Product / Process Change Notification (PCN)																															
<input type="checkbox"/> Major Change <input checked="" type="checkbox"/> Minor Change																															
PCN Number: PCN_IndXHMI_20241026 Affected Series: WE-XHMI Affected Order Codes: Please refer to table 1 PCN Date: 2024-07-26 (YYYY-MM-DD) Effective Date: 2024-10-26 (YYYY-MM-DD)	Change Category: <input type="checkbox"/> Equipment/Location <input checked="" type="checkbox"/> General Data <input type="checkbox"/> Material <input type="checkbox"/> Process <input type="checkbox"/> Product Design <input checked="" type="checkbox"/> Shipping/Packaging <input type="checkbox"/> Supplier <input type="checkbox"/> Software																														
Contact: Product Management Phone: +49 (0) 7942 - 945 5001 Fax: +49 (0) 7942 - 945 5179 E-Mail: pcn.eisos@we-online.com	Datasheet Change: <input checked="" type="checkbox"/> Yes <input type="checkbox"/> No Attachment: <input type="checkbox"/> Yes <input checked="" type="checkbox"/> No																														
Description of Change: <p>Due to packaging optimizations, Würth Elektronik eiSos will change the product's packing method. Würth Elektronik eiS

Table 2. Packaging Changes of affected Order Codes

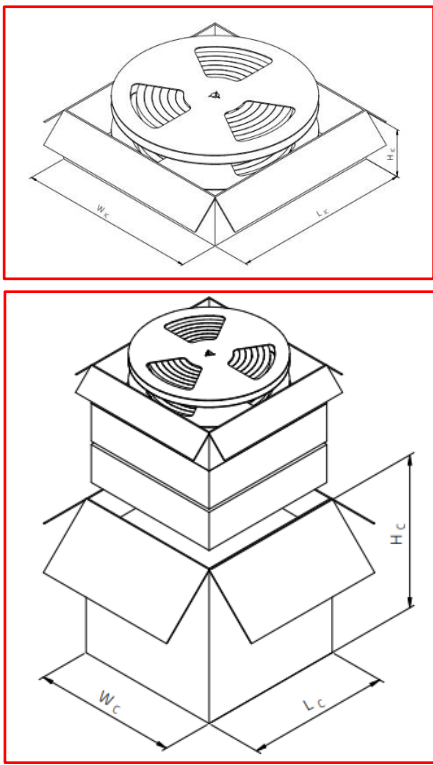
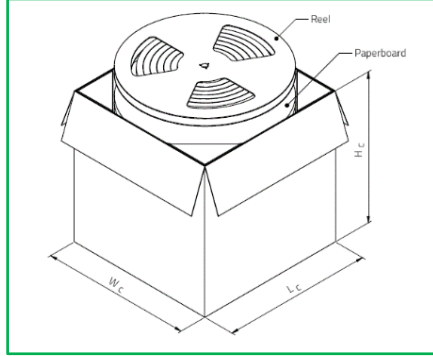
1. To reduce the amount of packaging waste in the product series WE-XHMI, with sizes and order codes indicated in table 1, the inner boxes will be omitted. No plastic filler will be used, and every reel will be stacked and separated by paperboard. The outer box dimension, reel quantity (pcs.), and box quantity (pcs.) will be updated accordingly. Additional details of the changes can be found in the table below:

Before Change	After Change
Datasheet packing drawings		
Overview of inner packing change
